Project: Remediation  
Contractor: \_\_\_\_\_  
Address: 1411 S. Portman #100  
RSN: 27411  
Permit Number: 196750  
Date: AUG 2 4 2007

# Cabinet Replacement at Aurora Dialysis

at  
1411 South Potomac Street, Suite 100  
Aurora, Colorado 80012

CITY OF AURORA  
BUILDING DIVISION  
APPROVED AS NOTED  
DATE: *AUG 24 2007*  
*07 196750*

T-1

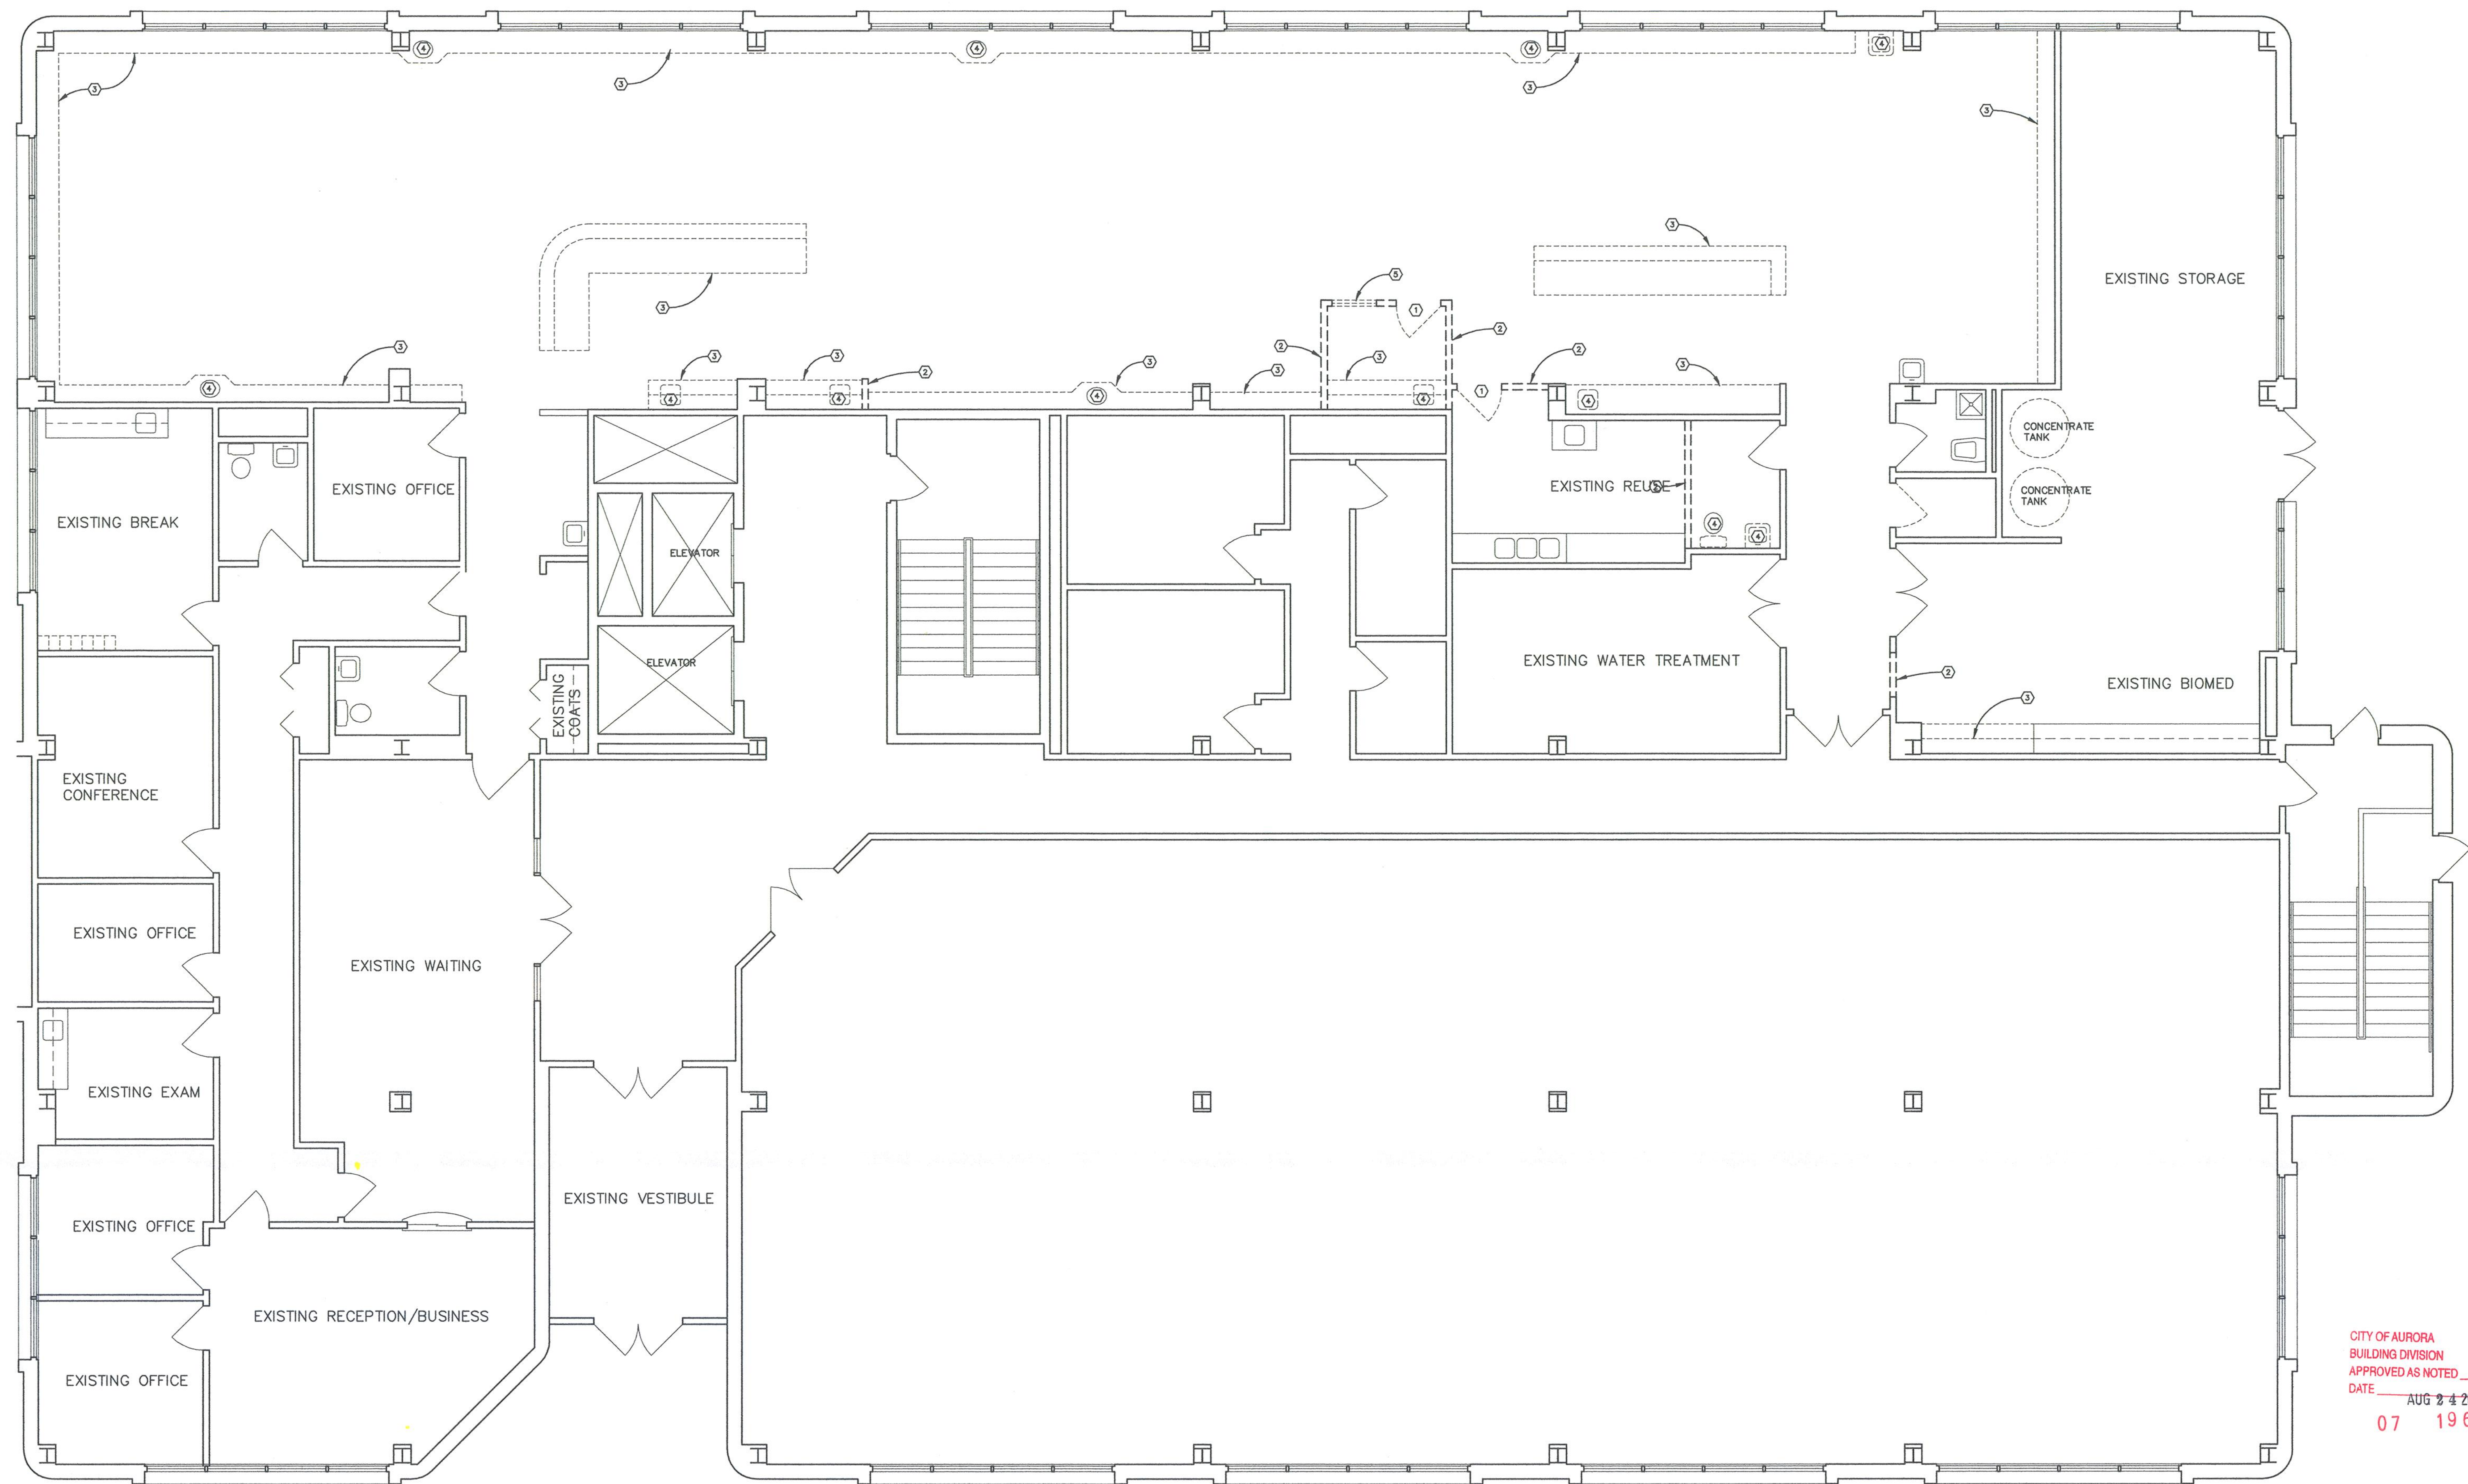
Attach drywall with screws per 2006 COA 22-145, 22-193

This plan is reviewed to IBC but the existing building is NOT converted to IBC. The construction type listed is UBC, Occupancy Group is IBC.

### M3

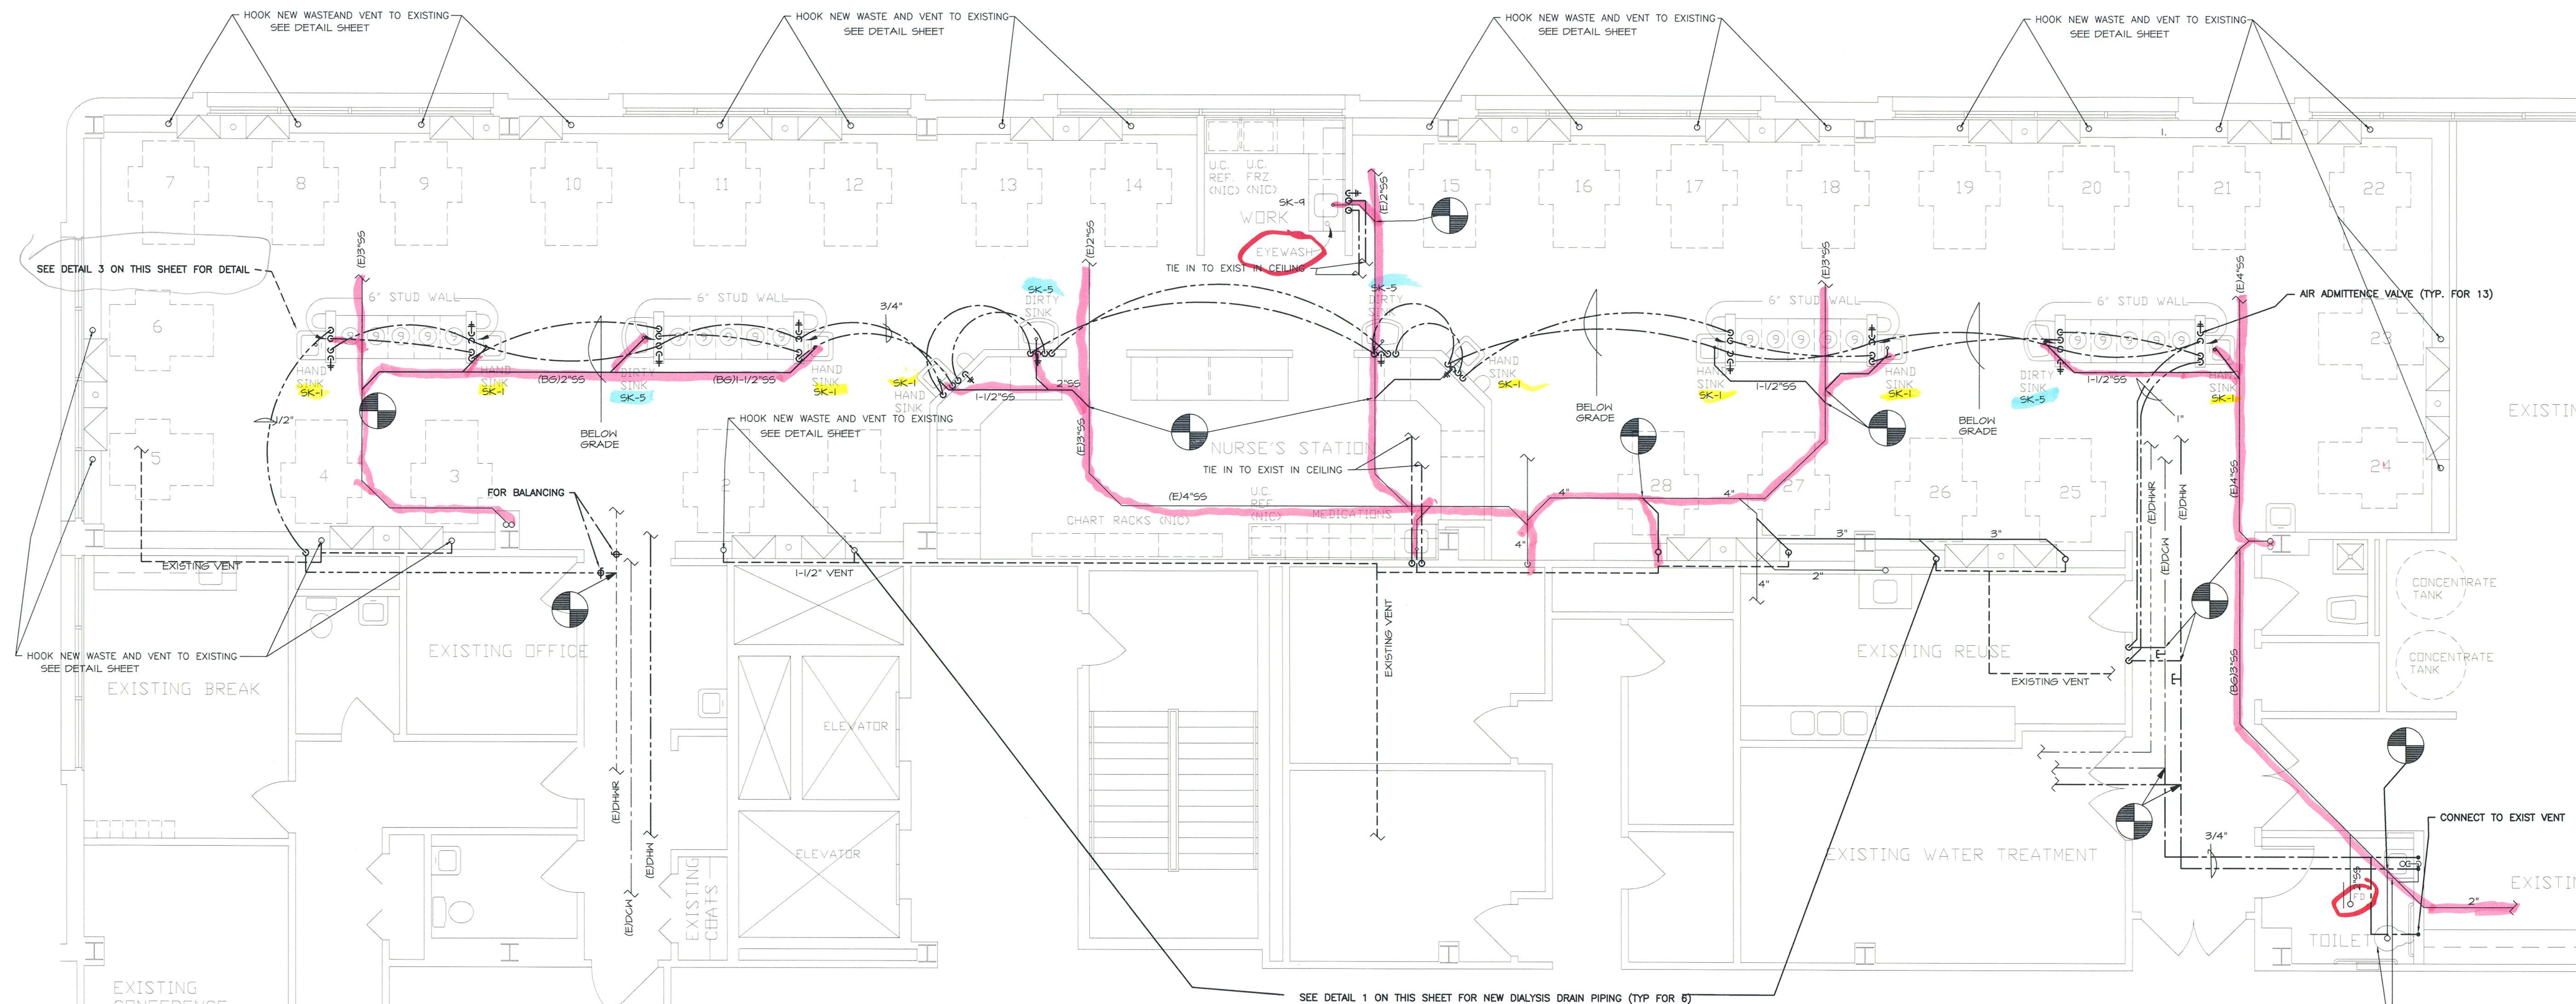
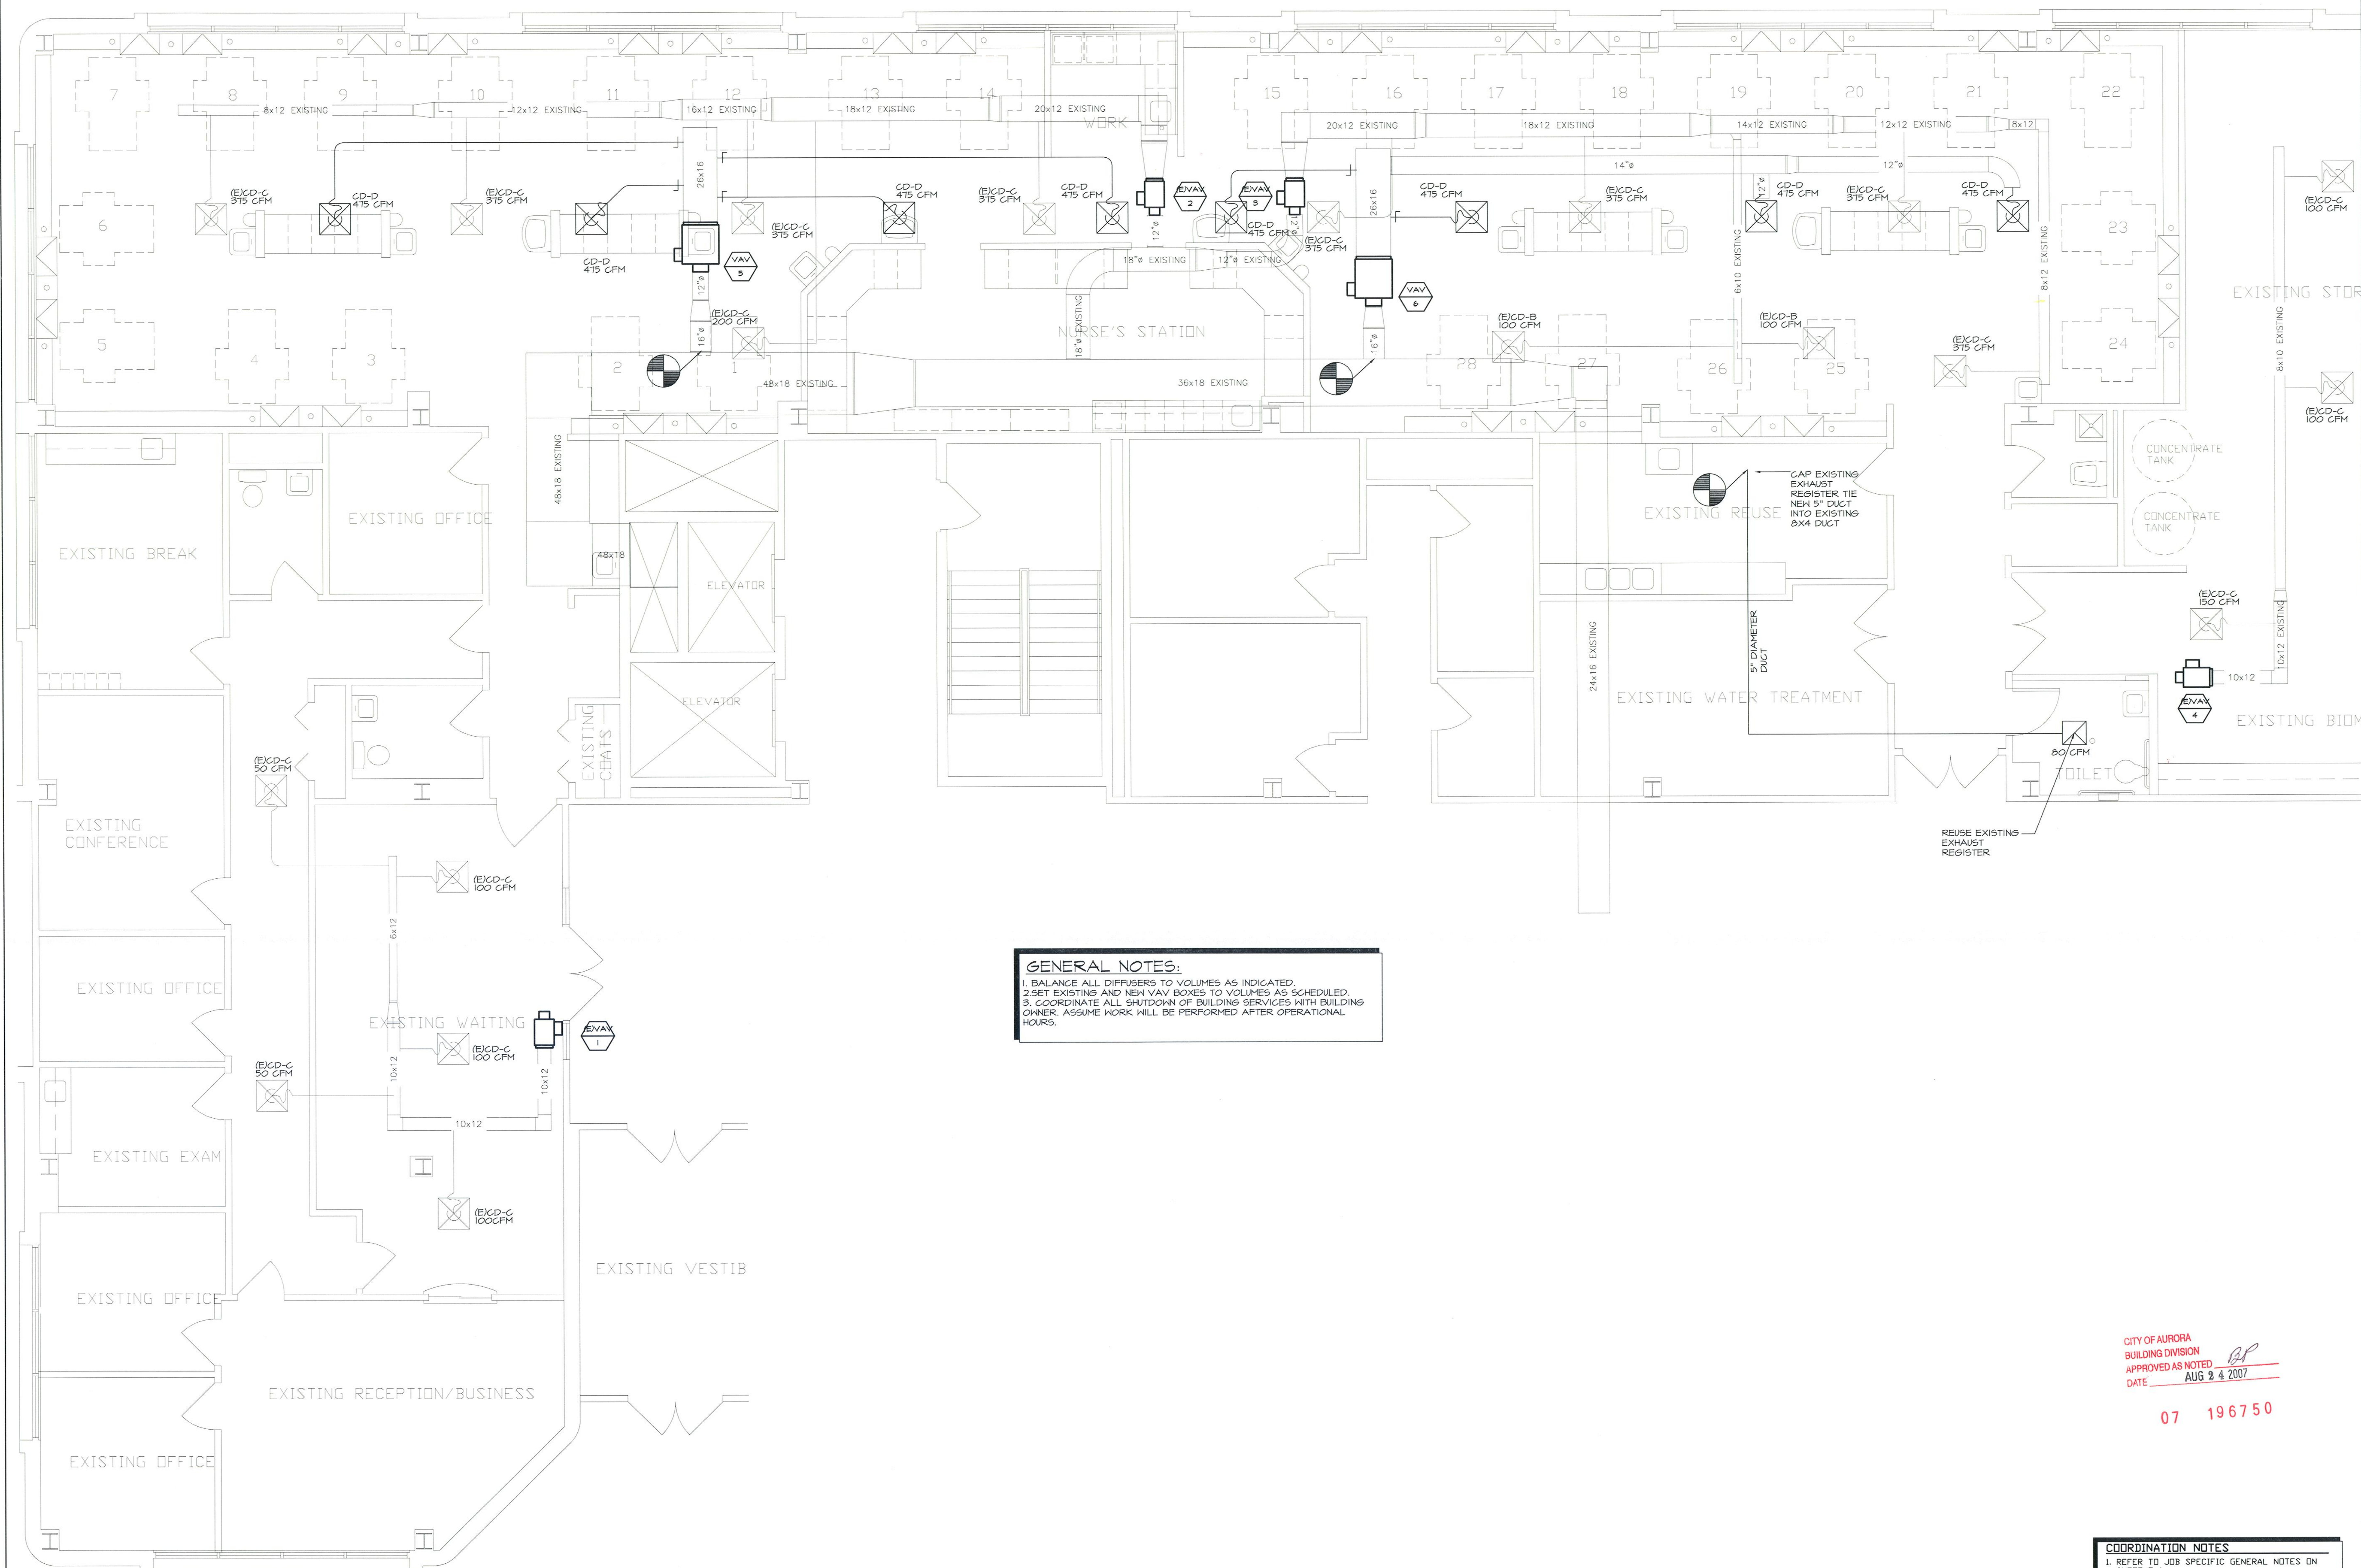
Dirty sink drains direct connection to SS
